Cooma Road Quarry Continued Operations Project

Response to Submissions

Prepared by
Umwelt (Australia) Pty Limited

on behalf of
Holcim Australia Pty Limited

Figure 2.1 – Day, Evening and Night-time Wind Roses for Summer

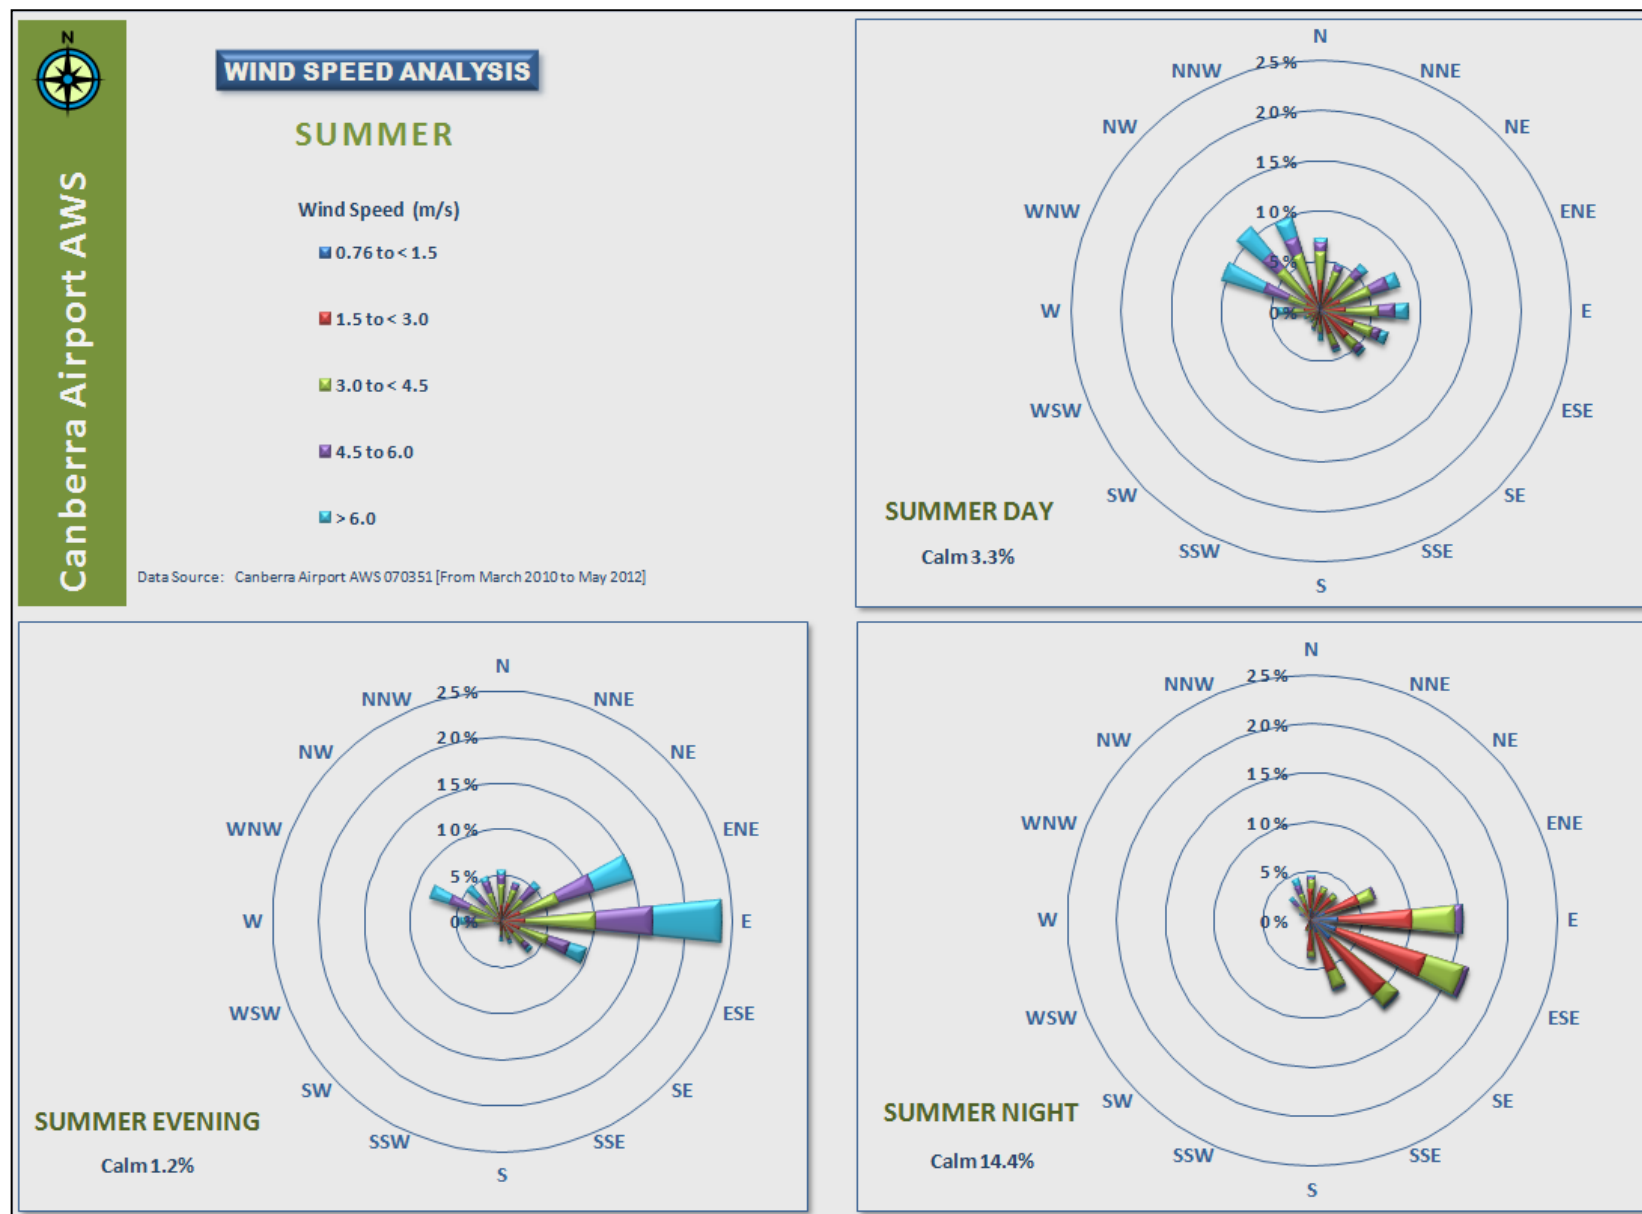
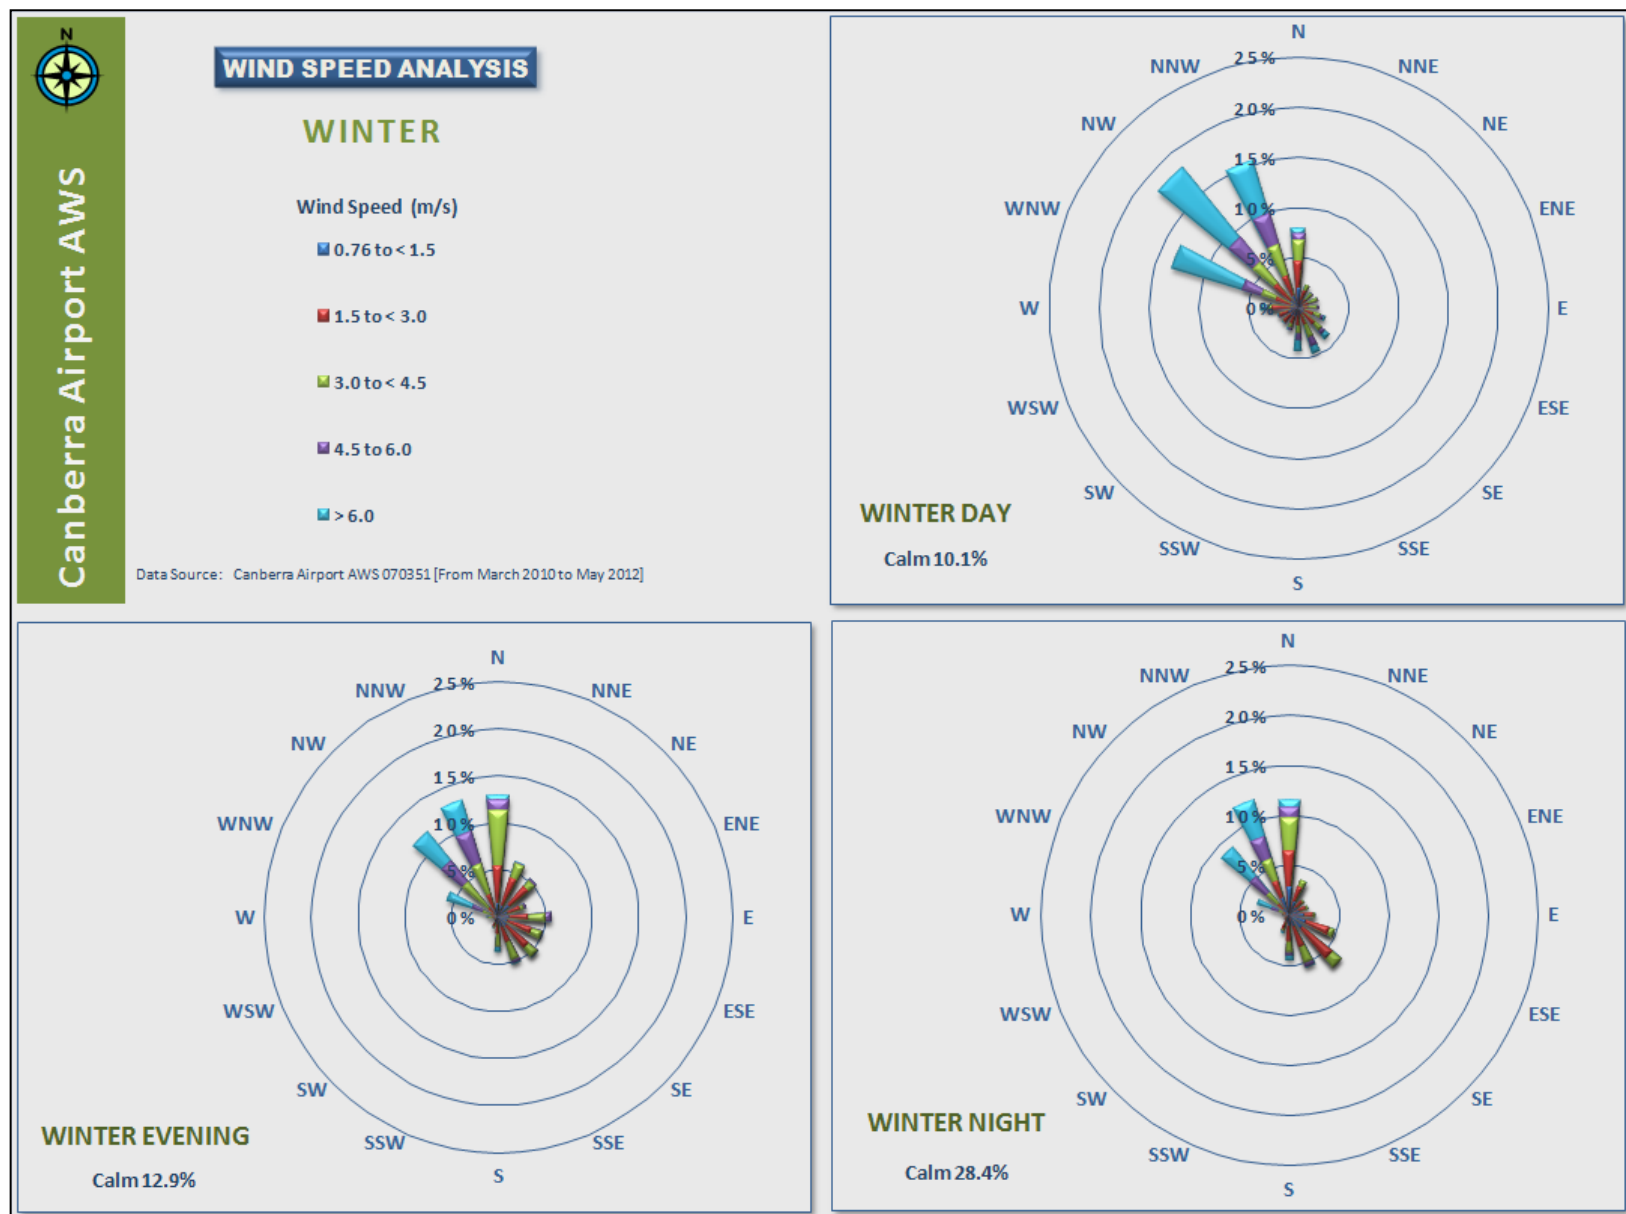
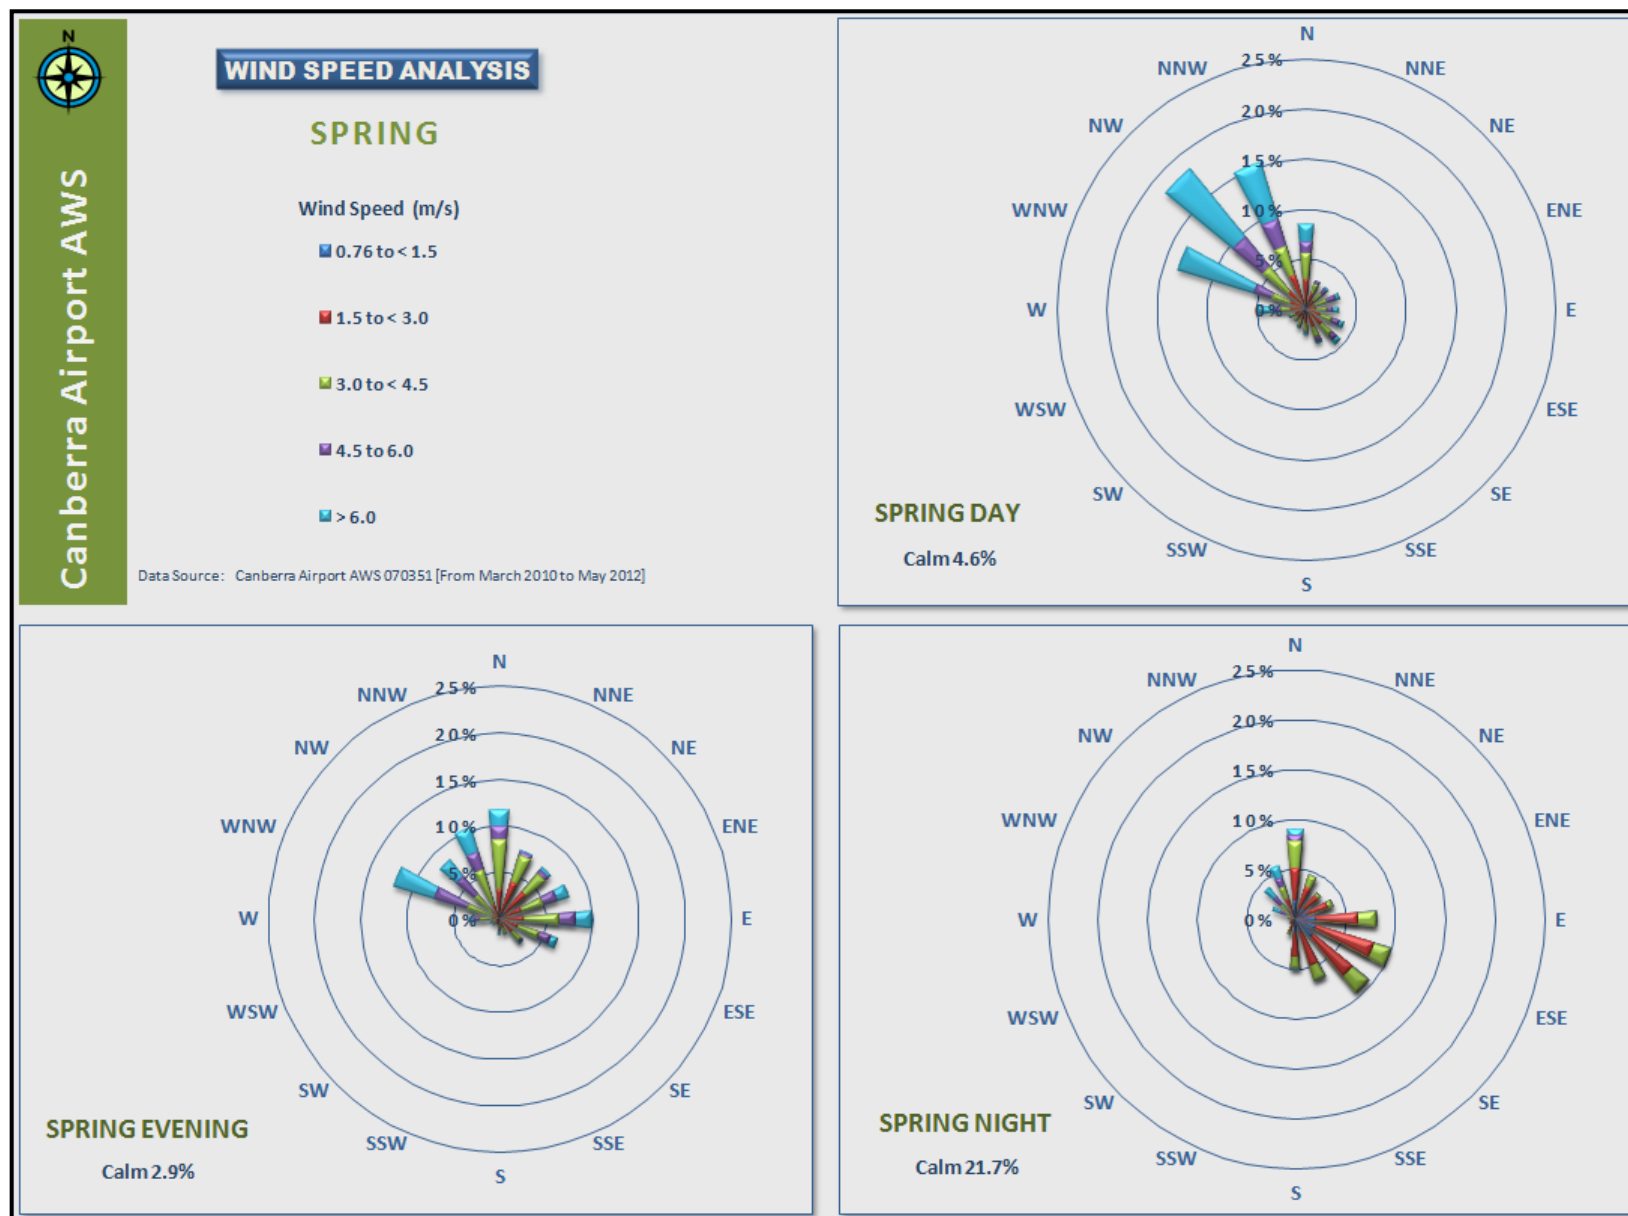
2. Vectored wind conditions above 30 per cent occur during the night-time in summer, autumn and spring and are predominantly associated with east-south-east winds (refer to the wind roses in **Figures 2.1 to 2.4**). However, the proposed development will not operate during the night time but will operate during the morning shoulder period commencing at 6.00am and the night-time vectored wind analysis in **Table 2.2** is not therefore applicable. The wind roses for the one hour period of 6.00am and 7.00am (presented in **Figure 2.5**) indicate gradient winds up to 3 m/s can occur from the east-south-east to south-south-east between 6.00 am and 7.00 am. The vectored wind analysis for this one hour period indicated it could occur approaching 30 per cent of the time. A sensitivity analysis was undertaken for the shoulder period to ensure that any potential for adverse impacts was not overlooked. The noise model, run for this specific condition, indicated worst case predicted noise levels to the north west of the Project of 31 to 32 dB(A). Therefore no further assessment was considered required to assess this aspect of the potential noise impacts as these levels were well below the Project-specific Noise Levels (PSNLs).

FIGURE 2.6

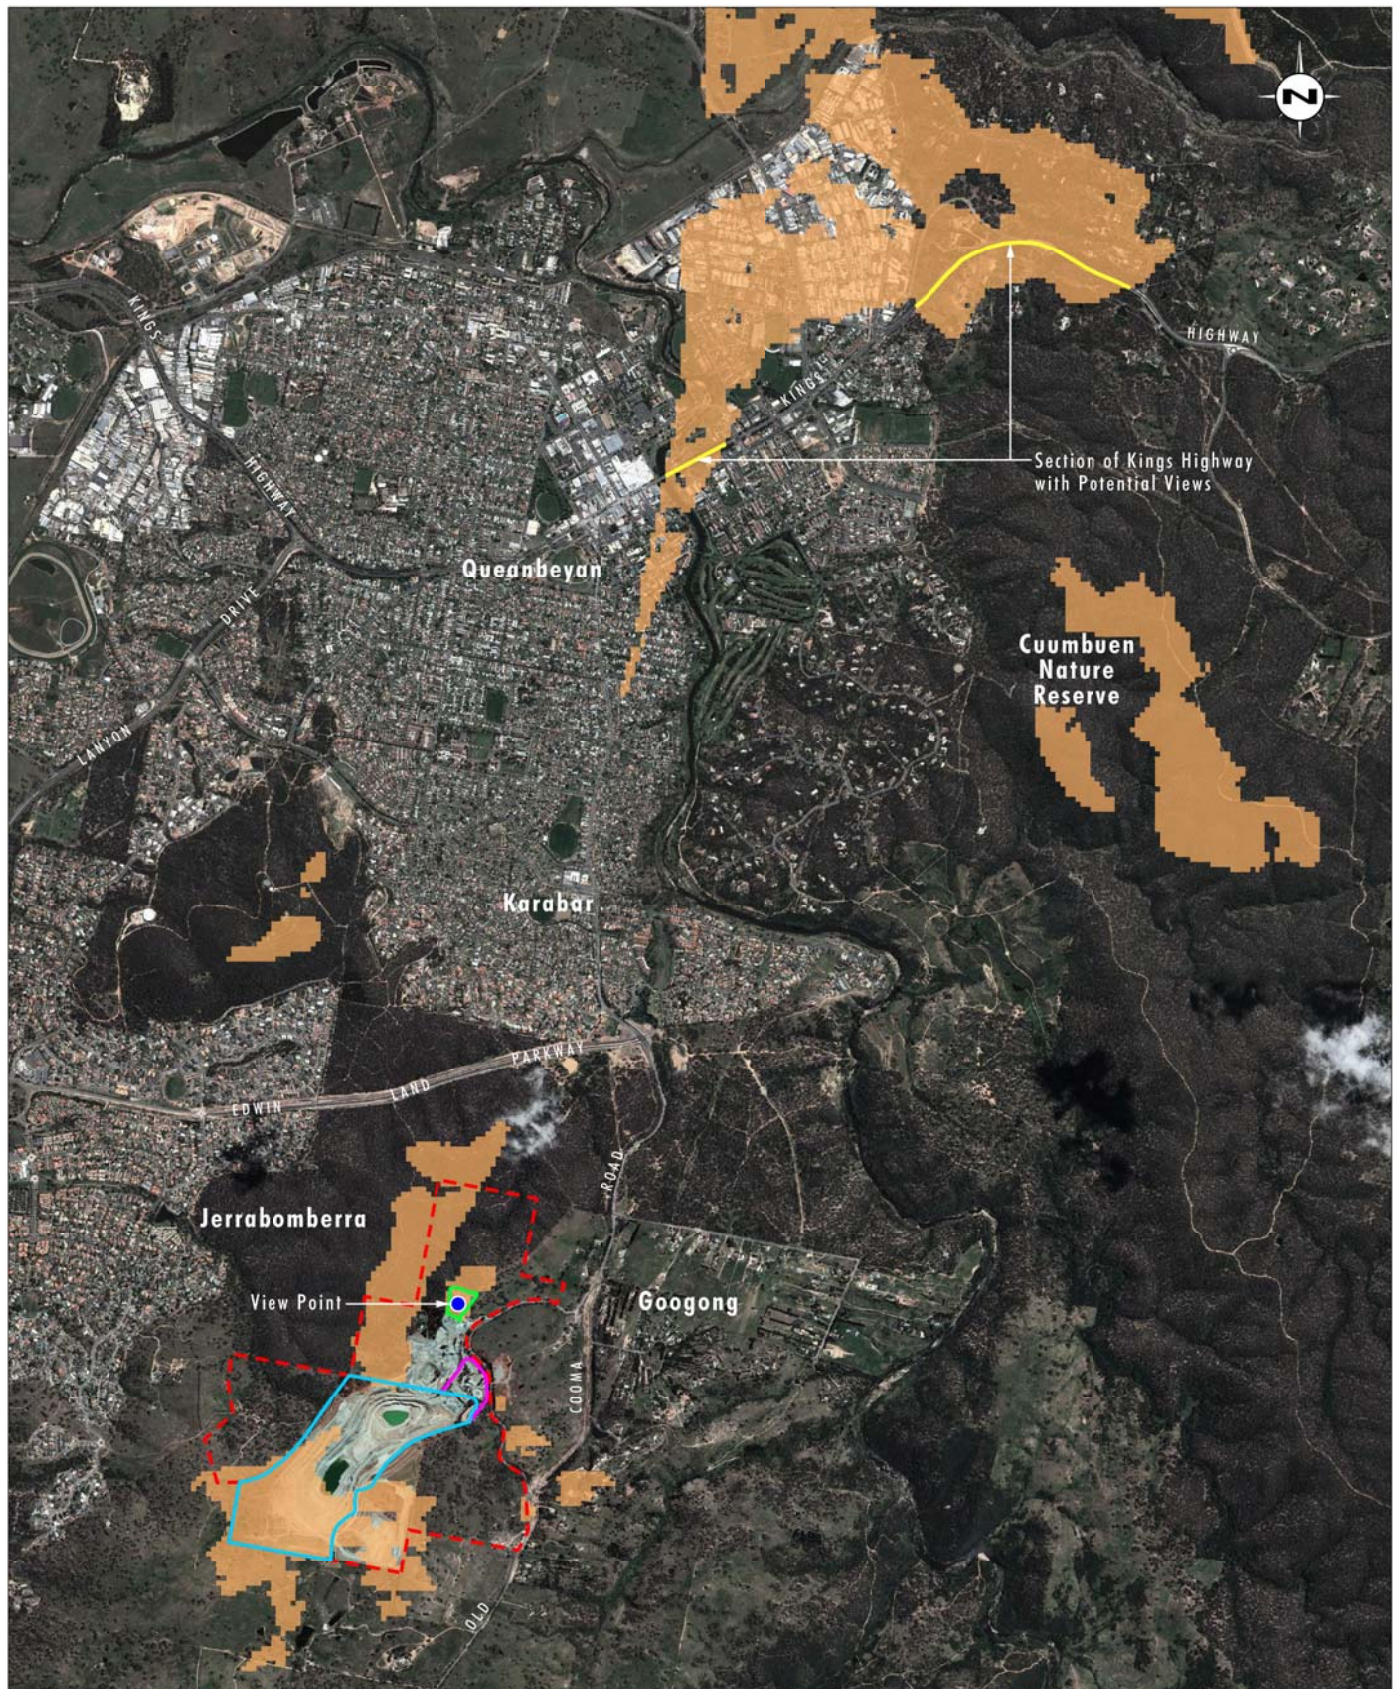
The visual analysis supplied in the EIS provides a very narrow view of the development from the immediate vicinity of the quarry. The analysis should also be conducted from vantage points such as Kings Highway (new alignment) and other vantage points which are further afield than the current analysis provides (Action 1.3 prior to consent).

The visual assessment, as presented in Section 5.12 of the EIS, focuses on the most potentially affected areas and is considered adequate for the Project considering the minimal change in the overall visibility of the Project. The changes proposed as part of the Project require only minimal changes to the existing quarry and the majority of changes will not result in changes in the visibility of the Project for the majority of surrounding community viewing locations. The changes required will have an insignificant impact on the visual amenity of all receivers. The major visual change from the Project is the new infrastructure area. Accordingly, the visual assessment focussed on the new infrastructure area.

As shown in **Figure 2.6**, a section of Kings Highway may have potential views of the proposed new infrastructure area. The analysis presented in **Figure 2.6** is based on topography only and does not make any allowances for vegetation or other shielding. As the new infrastructure area will mostly consist of a number of buildings, it is considered that any views that are not shielded by vegetation will be consistent with the views of the surrounding area (with numerous houses and other buildings).

It is noted that some views of the existing quarry pit are available from locations along the Kings Highway. The current views are primarily of an area of the existing quarry pit which is not proposed to change as a result of the Project. As shown in **Plate 2.1** and **Plate 2.2**, the existing views of the existing quarry pit from Kings Highway are over a long distance and are not highly visually intrusive. Based on the topography only analysis presented in **Figure 2.6**, the proposed quarry pit extension area and new infrastructure area may have some potential

views from a section of Kings Highway. However, topographic and vegetative shielding combined with the long distance views means that Kings Highway and areas further afield will have little to no change in visual amenity. Any distant views that are available of the new infrastructure area and extended quarry pit would be generally consistent with the existing views from these areas. Based on the above, the Project is not considered likely to result in significant changes to visual amenity from the Kings Highway area.
